Annex 1a – Amended RfG Regulation TC compared to the current Regulation

COMMISSION REGULATION (EU) .../...

establishing a network code on requirements for grid connection of generators

Figure (1)XX.a

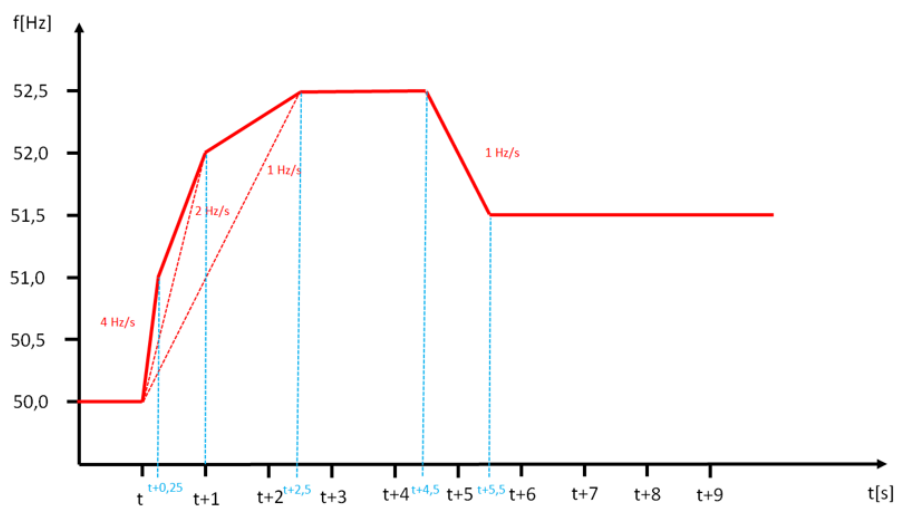
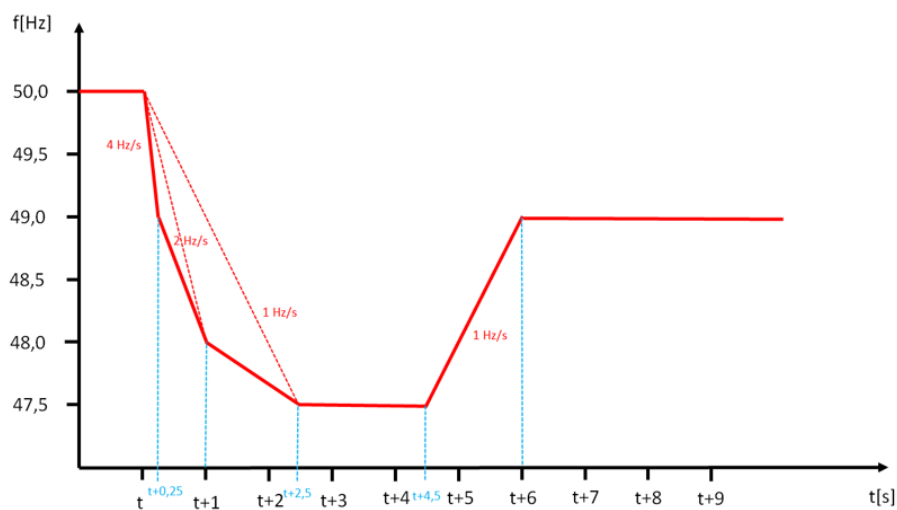
- (iii) without prejudice to paragraph (ii), a power park module shall also be capable of remaining connected to the network and operate through the sequence of rates-of-change-of-frequencies which are defined by the overfrequency against time profiles given in Figure (1)XX.a and the underfrequency against time profiles given in Figure (2)XX.b;

Figure (333)1

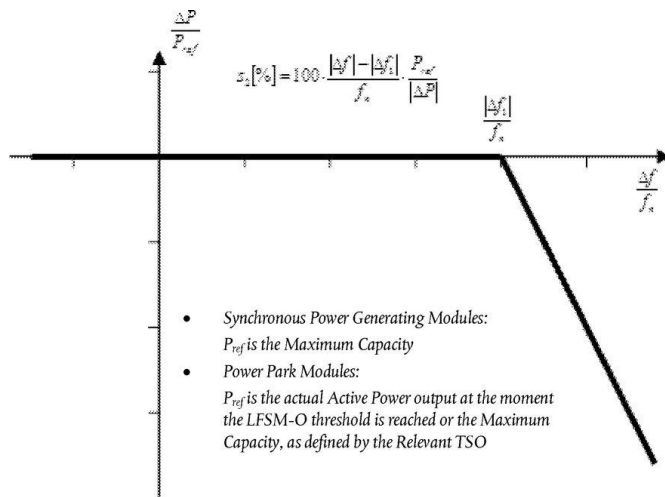
(h) An electricity storage module shall be capable of activating the provision of active power frequency response in LFSM-O from the current active power input or output automatically up to the maximum consumption capacity according to the indicative Figure (3)1Figure (3)1Figure (3)1 to the extent that is technically feasible. A

Switching from consumption to generation and vice versa should be as fast as technically feasible. The relevant system operator has the right to request the demonstration of technical evidence of the required switching time.

Figure (4)XX1

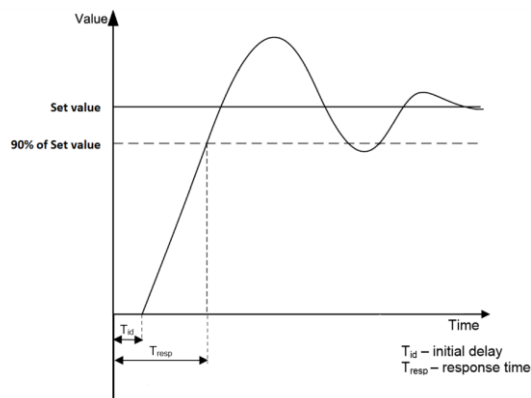
(e) the start of active power decrease (initial delay time T_{id} (Figure (4)XX1Figure (4)XX1Figure (4)XX1)) by the power-generating module shall not be intentionally delayed. the power-generating module shall be capable of activating a power frequency response with an initial delay that is as short as possible. If that delay is greater than two seconds, the power-generating facility owner shall justify the delay, providing technical evidence to the relevant TSO;

The response time, T_{resp} in Figure (4)XX1Figure (4)XX1Figure (4)XX1, for active power decrease in case of increasing frequency, shall be as fast as technically feasible and as described below:

- (i) for synchronous power-generating module: less or equal to 8 seconds for an active power setpoint change of 45% maximum power.
- (ii) for power park module: less or equal to 2 seconds for an active power setpoint change of 50% maximum power.

Figure (666)YY1

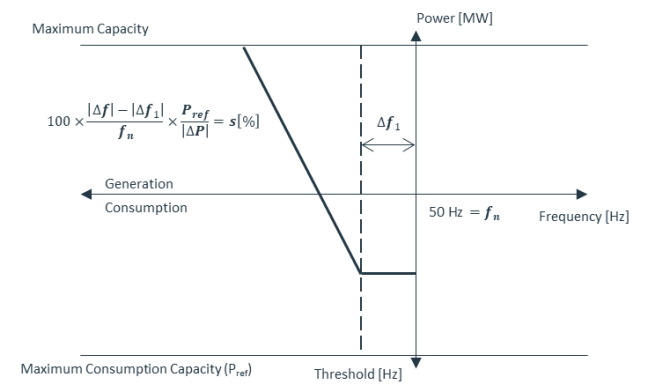
(a) An electricity storage module shall be capable of activating the provision of active power frequency response from the current active power input or output automatically up to the maximum capacity according to the indicative Figure (6)YY1Figure (6)YY1Figure (6)YY1. The relevant TSO shall specify a frequency threshold and a droop setting;

(b) The electricity storage module shall stay and operate stably in this specific mode as long as the frequency is below the frequency threshold according to its content of energy. When LFSM-U-ESM is active, the LFSM-U-ESM setpoint shall prevail over any other active power setpoints. If the frequency recovers the electricity storage module shall follow the same power-frequency characteristic until it is back to its prior state of active power input/output. The electricity storage module shall be able to receive and react on an external signal allowing the relevant system operator to block active power LFSM-U-ESM mode in real-time. The TSO in coordination with the RSO-relevant system operator shall define the framework conditions for the use of this function.

Figure (7)XX.c

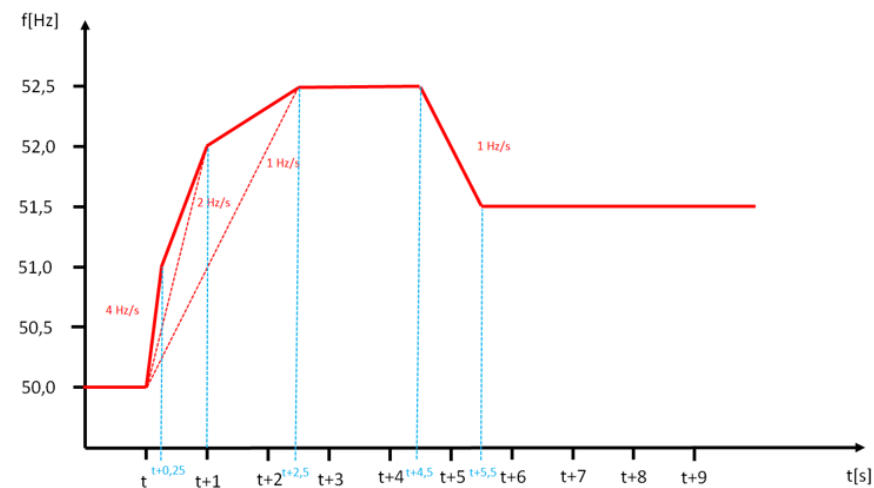
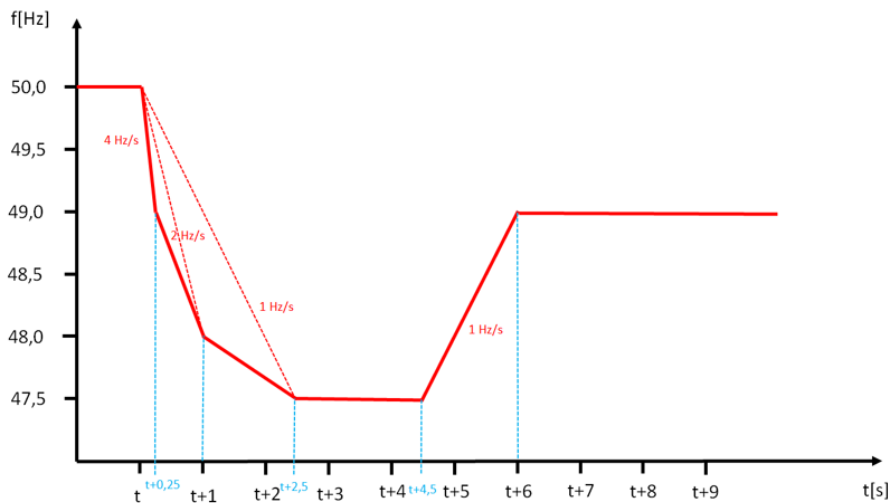
(ii) Without prejudice to paragraph ~~Article 13a~~1(a), type EV1 and EV2 V2G electric vehicles and associated V2G electric vehicle supply equipment shall be capable of ~~staying~~remaining connected to the network and operate at the sequence of rates-of-change-of-frequencies which are defined considering the overfrequency against time profiles given in Figure (7)XX.cFigure (7)XX.cFigure (7)XX.e and the underfrequency against time profiles given in Figure (8)XX.dFigure (8)XX.dFigure (9)XX.d.

Figure (9)YY2

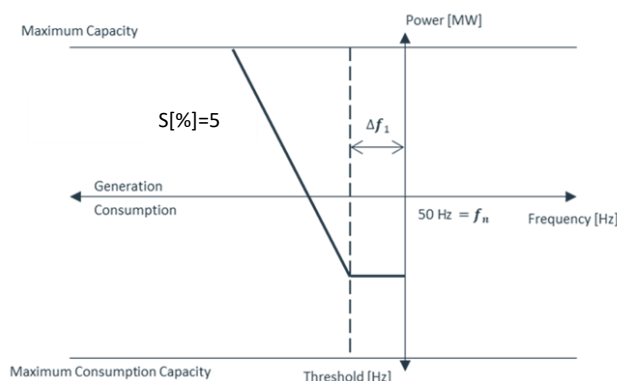
- (a) A type EV1 and EV2 V2G electric vehicle and associated V2G electric vehicle supply equipments shall be capable of activating the provision of active power frequency response from the current active power input/output automatically up to the maximum capacity according to the indicative Figure (9)YY2Figure (9)YY2Figure (9)YY2 at a frequency threshold and with the droop setting;

Figure (10)1X1

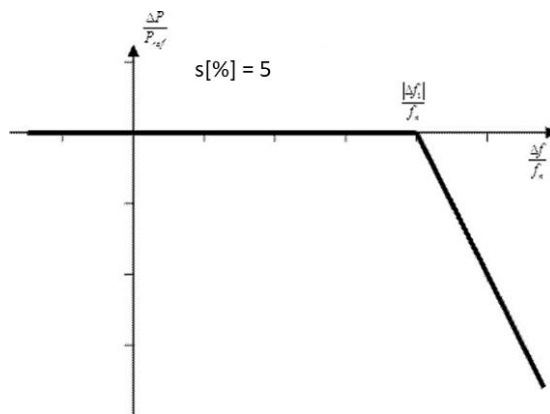
(b) A Type EV1 and EV2 V2G electric vehicles and associated V2G electric vehicle supply equipment, which is injecting active power during an overfrequency event, shall activate the provision of active power frequency response according to [Figure \(10\)1X1](#) at the frequency threshold Δf_1 equal to 50.2 Hz (inclusive), except for synchronous area IE where the frequency threshold shall be 50.5 Hz (inclusive);

Figure (11)XX3

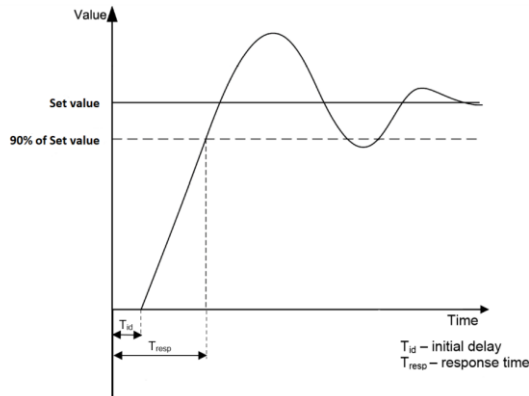
- (e) The response time, T_{resp} in Figure (11)XX3Figure (11)XX3Figure (11)XX3, shall be less or equal to 0.5 s for an active power setpoint change of 100% of P_{max} excluding the time for switching from consumption to generation or vice versa, and excluding the time needed to activate from the charging pause;

(f) The response time T_{resp} ([Figure \(11\)XX3](#)) for active power decrease in case of increasing frequency, shall be as fast a technically feasible and less or equal to 2 seconds for an active power setpoint change of 50% maximum power.

Figure (13)X

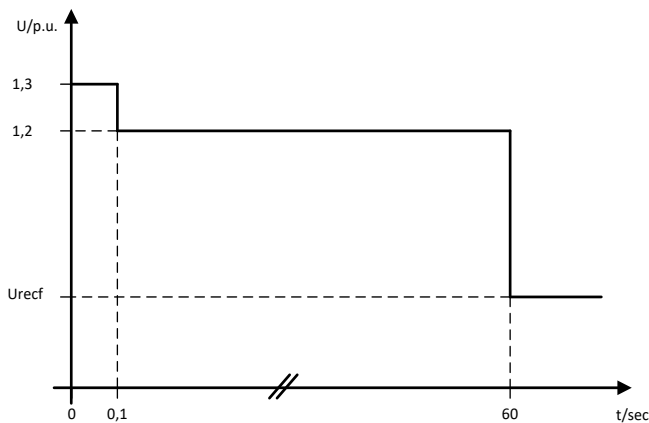
- (b) fault-ride-through capabilities in case of asymmetrical faults shall be specified by each TSO.
- (c) The power-generating module shall be capable of operating stably without disconnecting from the network, if none of the phase-to-phase voltages exceeds the voltage-against-time-profile defined in Figure (13)XFigure (13)XFigure (13)X at the connection point. The relevant system operator, in coordination with the relevant TSO, may define longer times for operation, if it is required to preserve or to restore system security. The power-generating facility owner shall not unreasonably withhold consent to apply longer times for operation, taking account of their economic and technical feasibility.

The diagram represents the higher limit of a voltage-against-time profile of the voltage at the connection point, expressed as the ratio of its actual value and its reference 1 pu value, before, during and after a fault. U_{ref} is the maximum voltage specified in paragraph 2 and in Article 13(12).
